ADDENDUM NO. 2

TO: PLANS AND SPECIFICATIONS FOR STATE OF MISSOURI

Construct Classroom Addition
Fort Leonard Wood Readiness Center
Fort Leonard Wood, MO
PROJECT NO.: T2042-01

July 6, 2023

SHEET TITLE:
**BUILDING
SECTIONS**

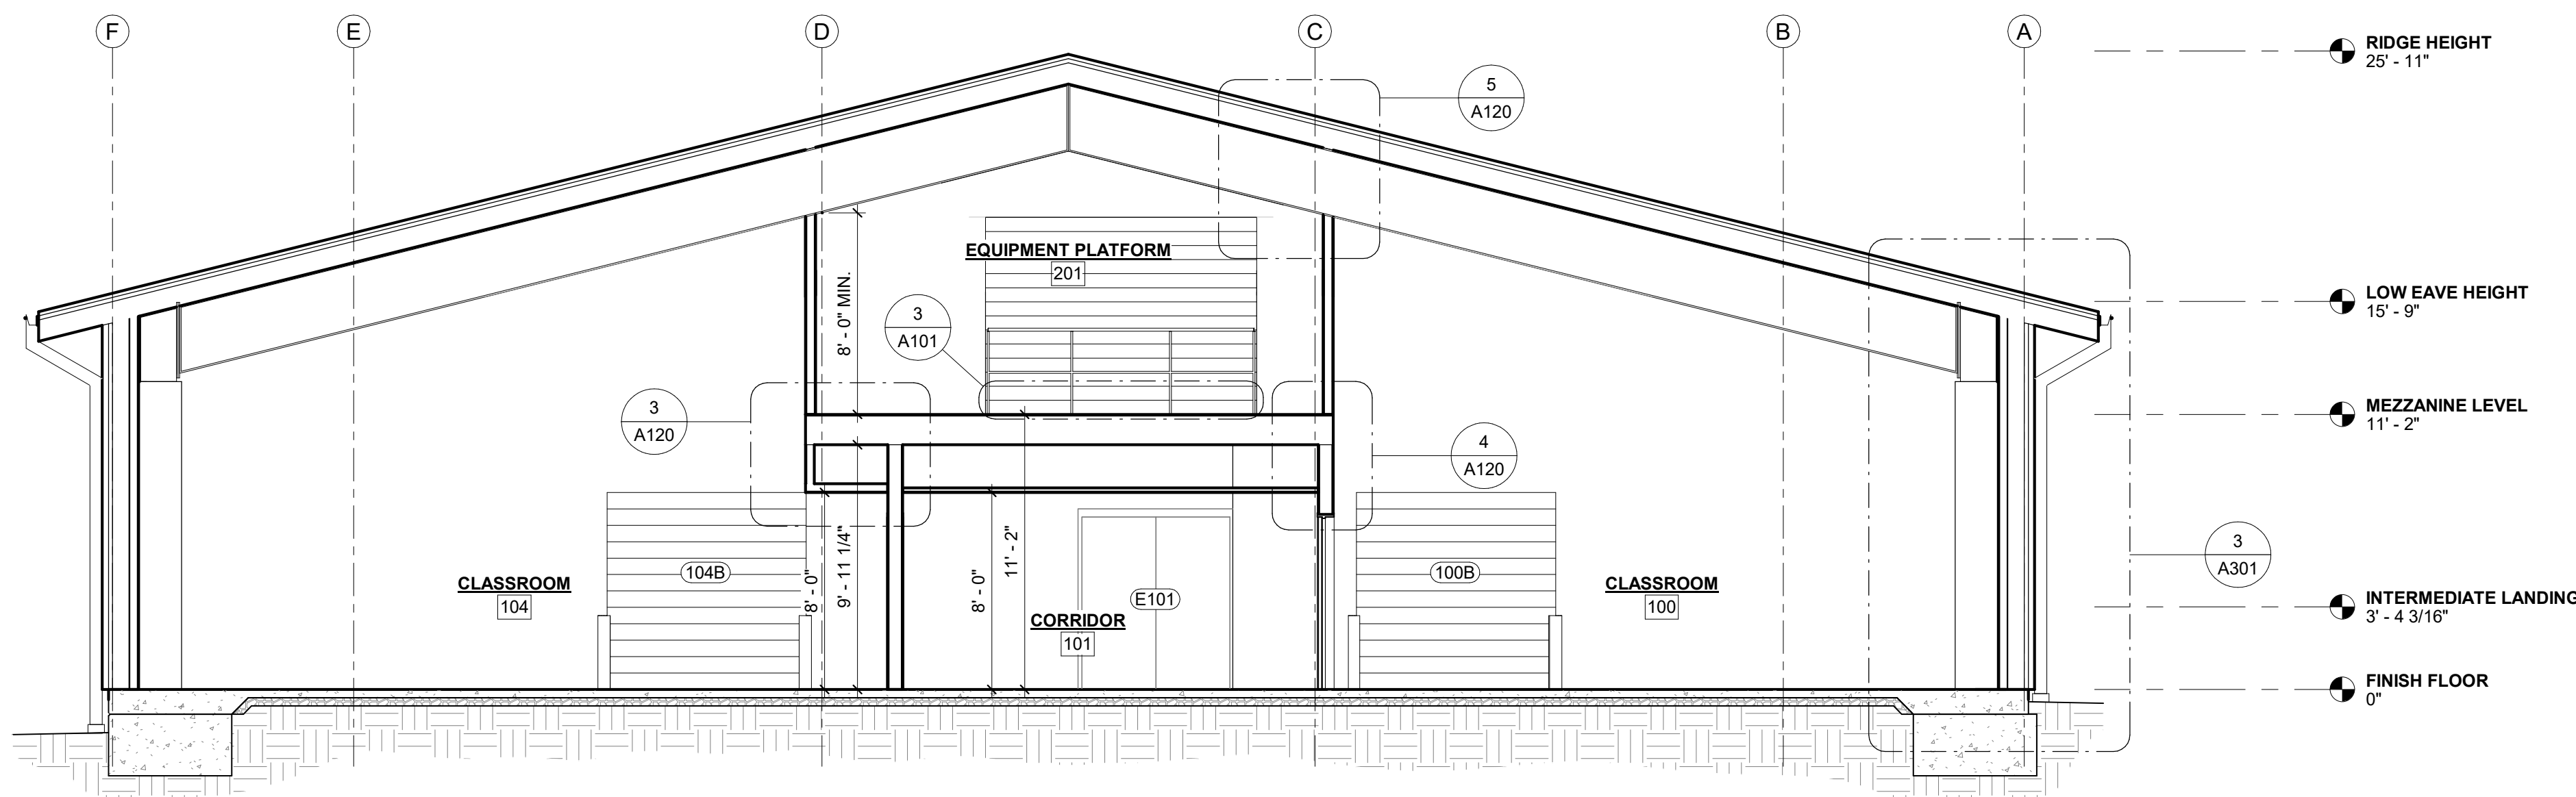
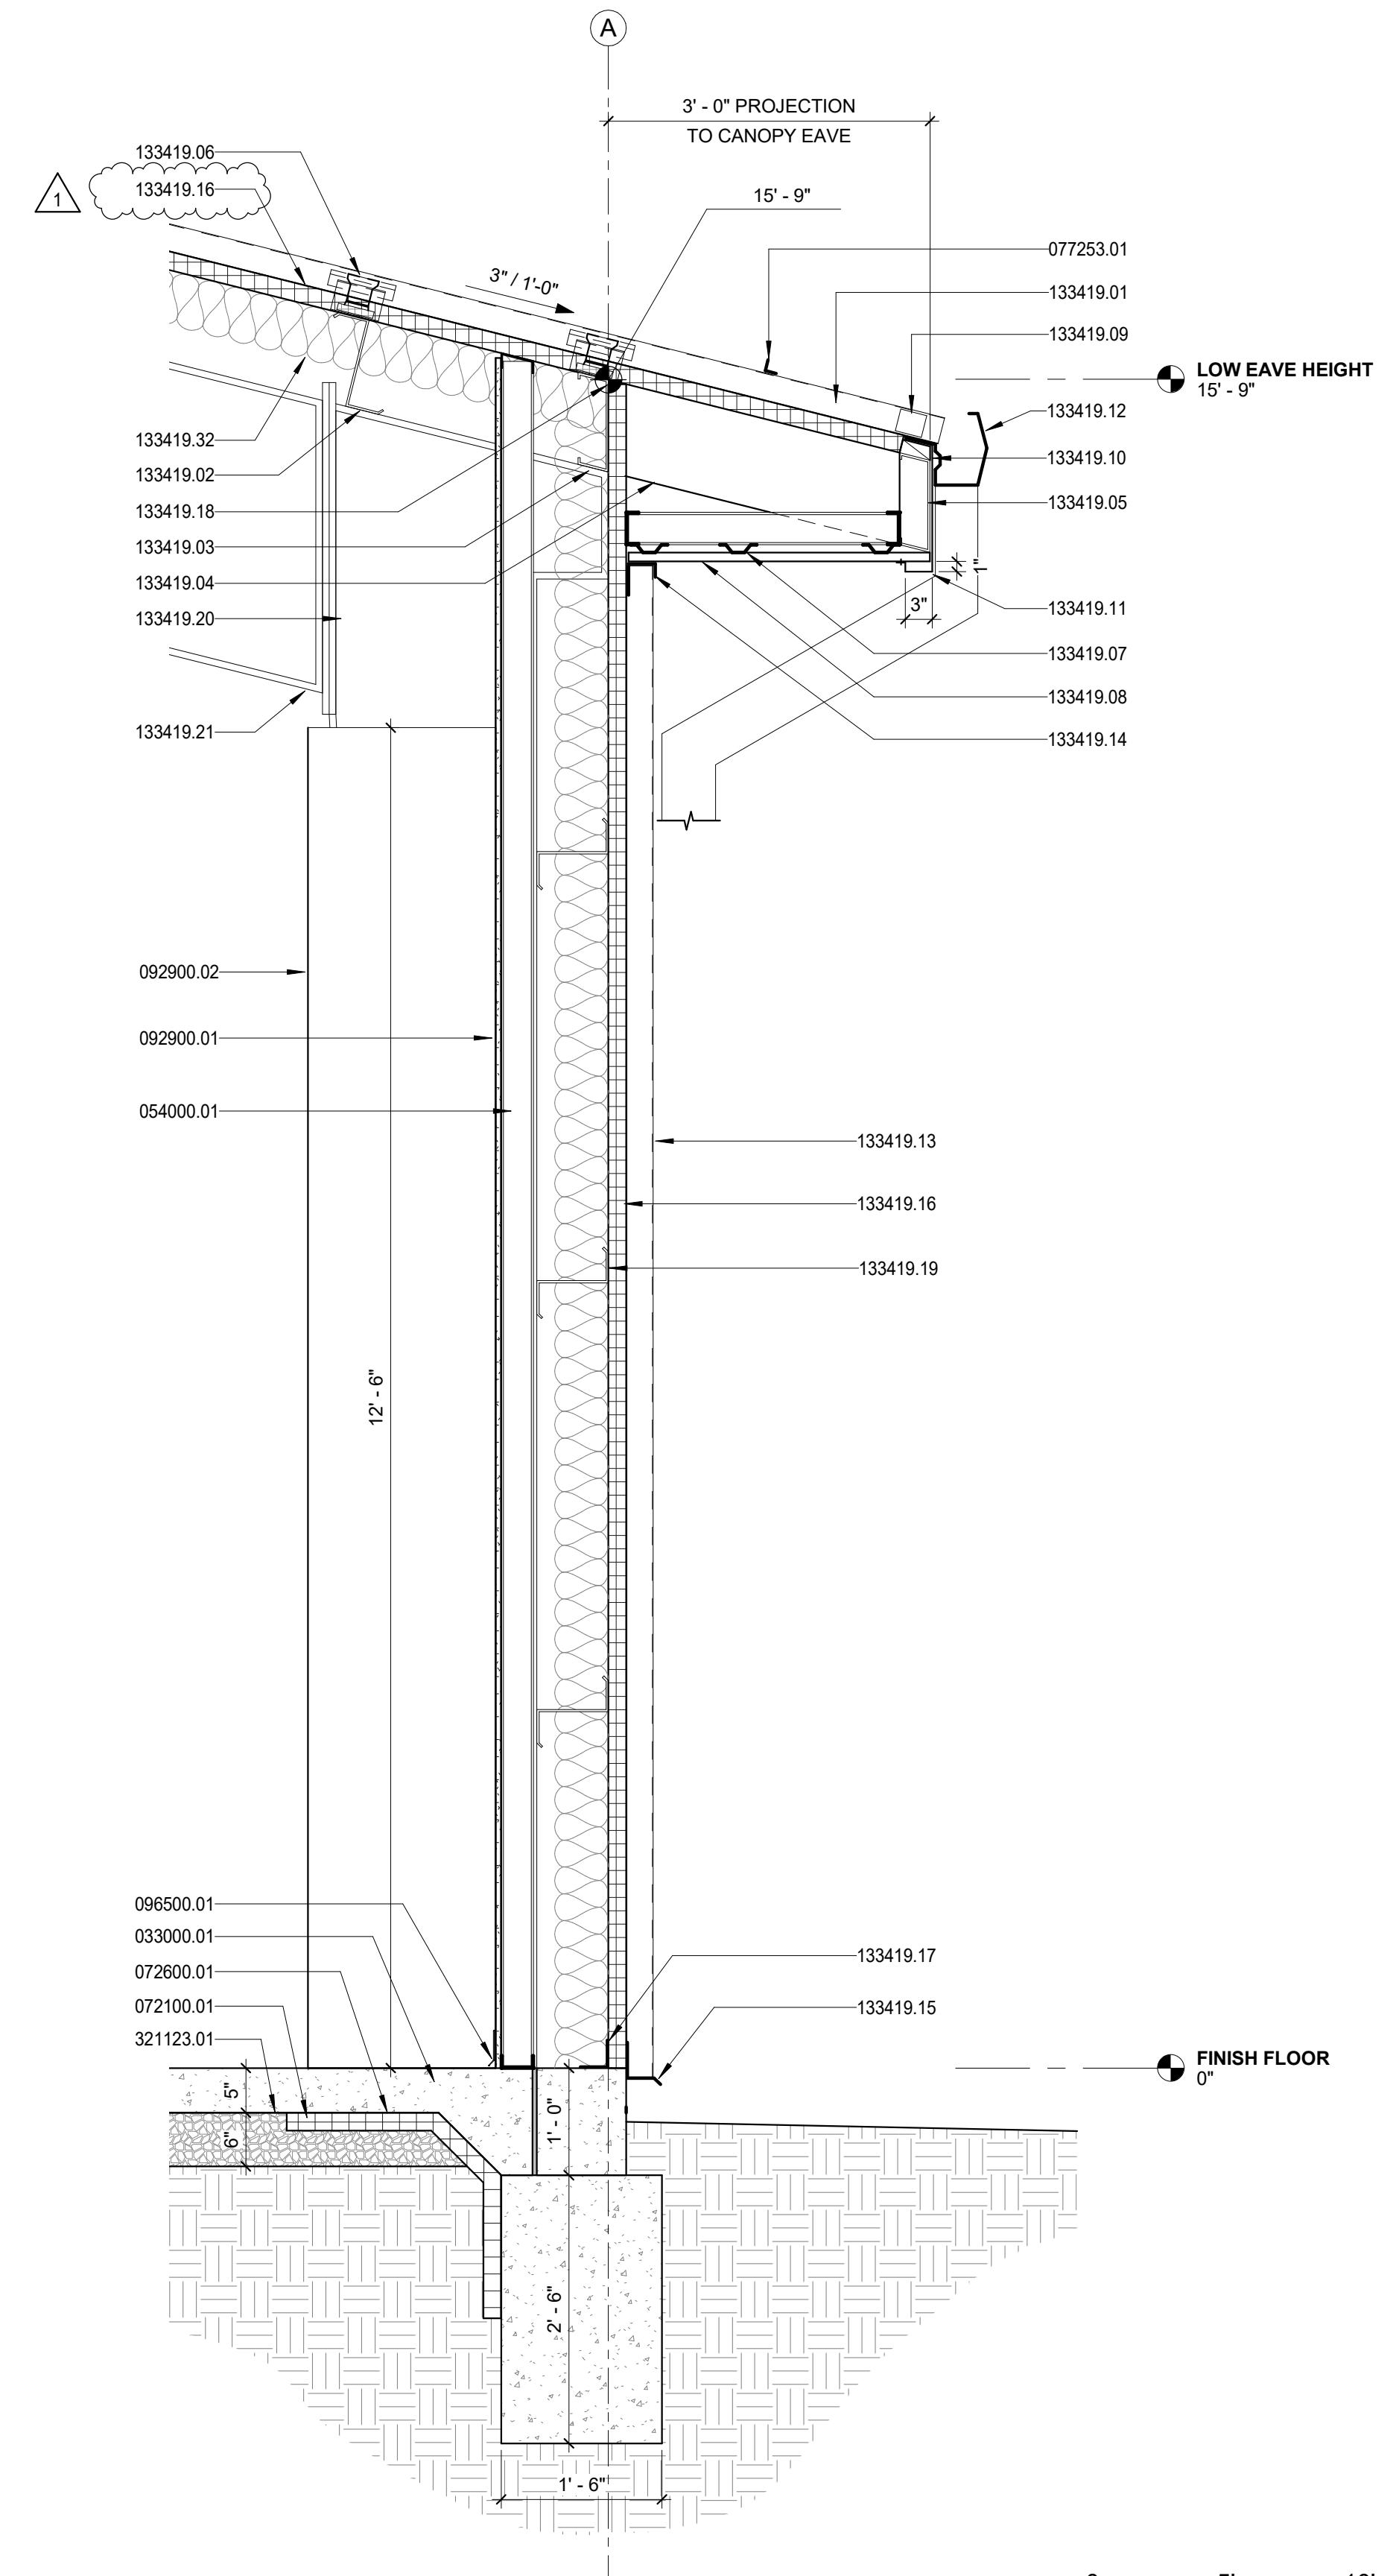
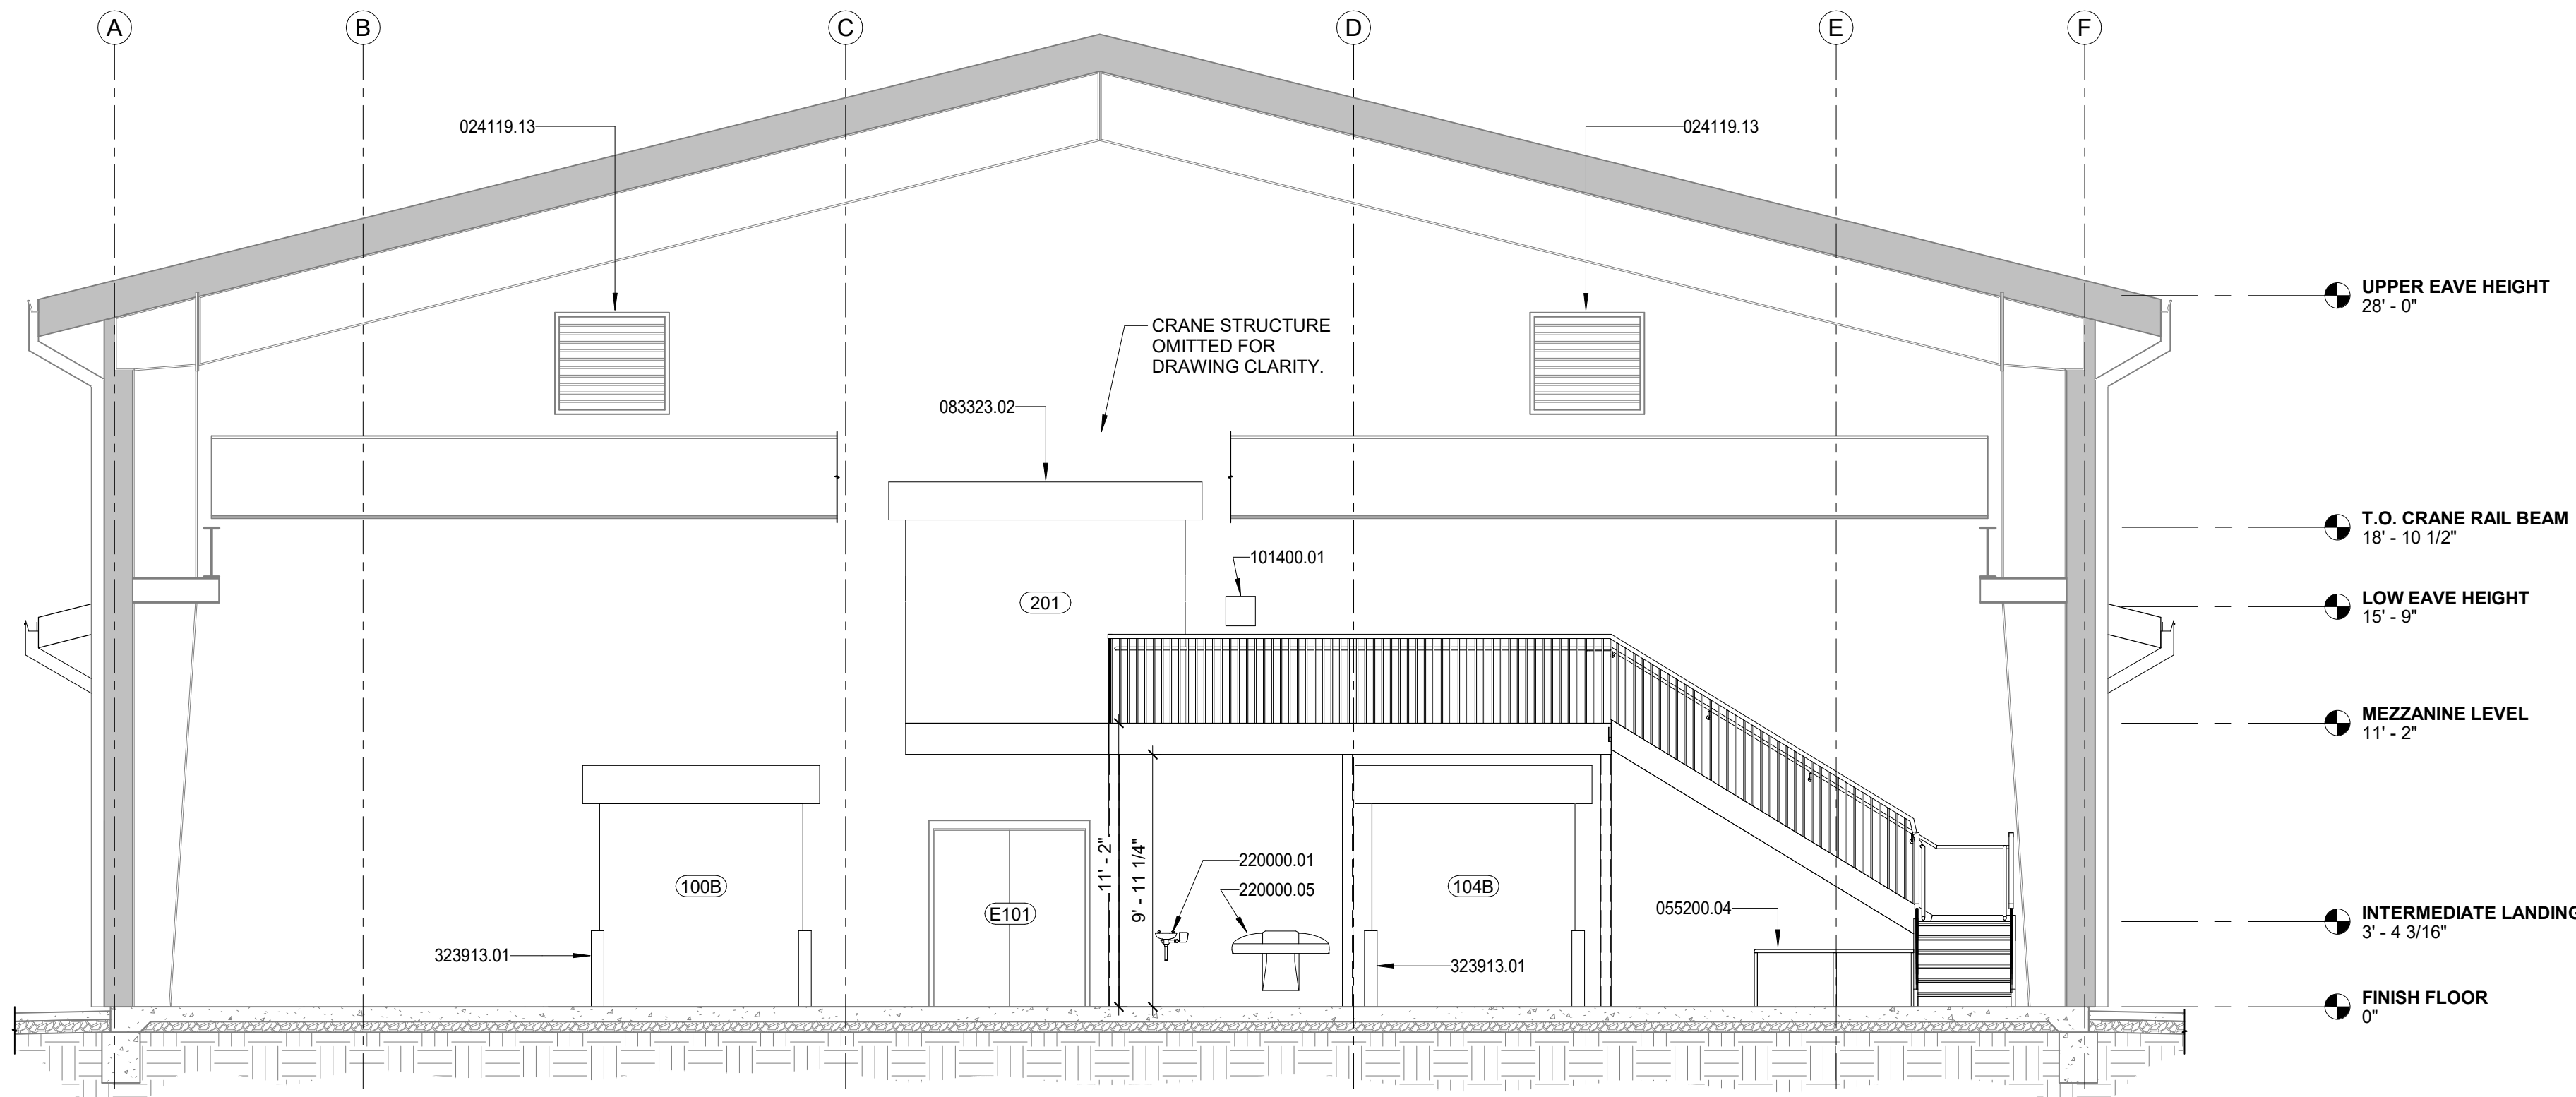
- a. CHANGE roof rigid insulation keynote from 133419.31 to 133419.16, which reads as follows:
- 2" THICK, MIN. R-13 RIGID INSULATION, TAPE & SEAL ALL JOINTS.

| VALUE | DESCRIPTION |
|-----------|--|
| 133419.16 | 2" THICK, MIN. R-13 RIGID INSULATION, TAPE & SEAL ALL JOINTS |
